Overview: Production error; immobilizer wire (orange/black) in pin position #4 instead of pin position #5. Although an effort to correct the issue was made, some quantity of harnesses did get shipped before the issue was spotted. We are advising to inspect the harness BLADE connector before attempting to install the harness and program the module.

Overview: The FTI-STP1 harness may require modification for use in **automatic transmission (AT)** applications, some of the product was able to be modified before release, but a small quantity was released before being able to be modified internally.

FTI-STP1: Installation and Configuration Notes

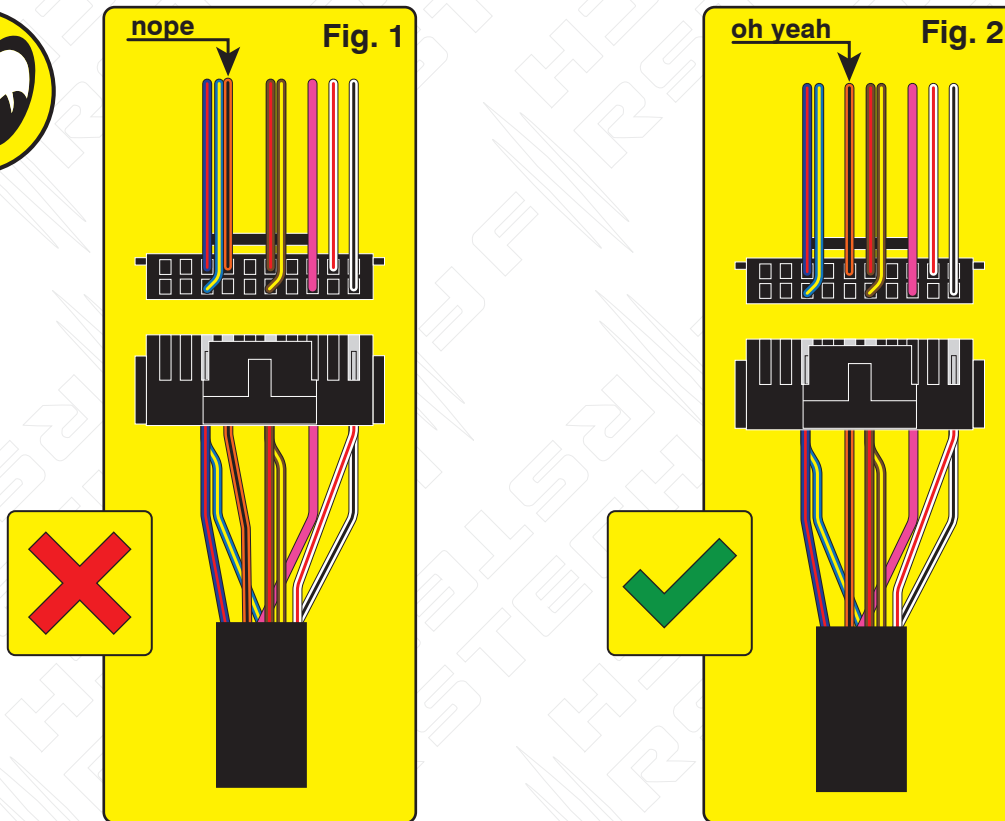
Issue: Module fails to program to vehicle, will not allow the vehicle to be remote started.

Correction: Step 1.) Locate the orange/black wire and confirm whether it is positioned as illustrated in Fig. 1 or Fig. 2. If the wire is as illustrated in Fig.1, proceed with Step 2 through 5 and complete the repair procedure outlined, if the wire is as illustrated in Fig. 2, correction is not necessary, proceed with harness installation and module programming.

Step 2.) Using a pick, lightly depress the catch that secures the terminal in the housing then remove the wire and terminal from the housing.

Step 3.) Using a fine tip razor or utility knife, insert the blade beneath the terminal catch and raise it slightly, so that it can be reused to secure the terminal when reinserted into the BLADE connector housing.

Step 4.) Refer to Fig. 2 for correct position of the orange/black wire (next to brown/red) then reinsert the terminal, pressing lightly until the catch 'snaps' into place, securing the terminal in the connector housing.

Step 5.) The repair is complete, proceed with installation and programming.

MODIFICATION REQUIRED FOR AUTOMATIC TRANSMISSION APPLICATIONS ONLY

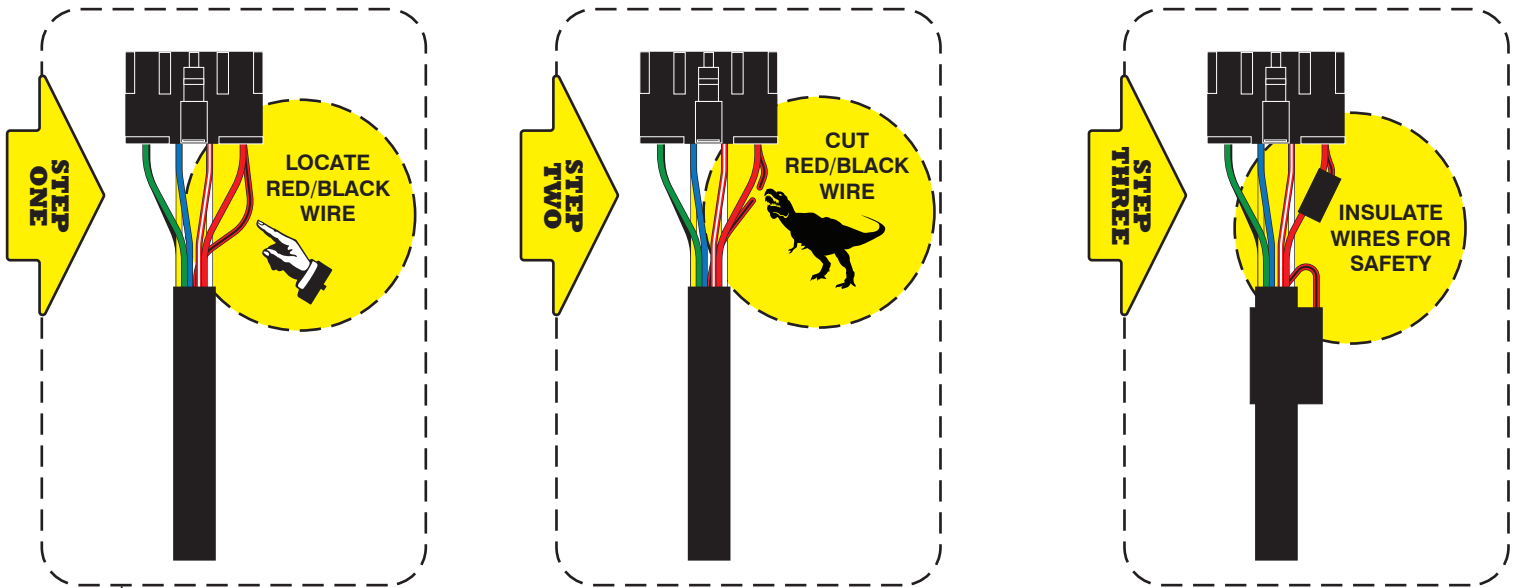
Issue: The FTI-STP1 T-harness has been designed to be compatible with AT (automatic transmission) & MT (manual transmission) applications, but due to a production oversight, the selection mechanism was defaulted to MT mode.

Using a harness configured for an MT application, in an AT equipped vehicle, could result in vehicle module damage, it is advised that the harness be returned to AT mode before installation in vehicles equipped with an automatic transmission.

Correction: Locate the **red/black (+ Clutch)** wire provided in the CN1 connector of the main harness assembly. Cut the **red/black** wire, either flush to the CN1 connector, or leaving enough wire exposed so that you can insulate and secure the ends of the wire that remain after cutting. Insulate each of the remaining ends of the **red/black** wire and secure to prevent any possibility of a short circuit.

If the red/black wire already been disconnected, no further modification is required for AT equipped vehicles.
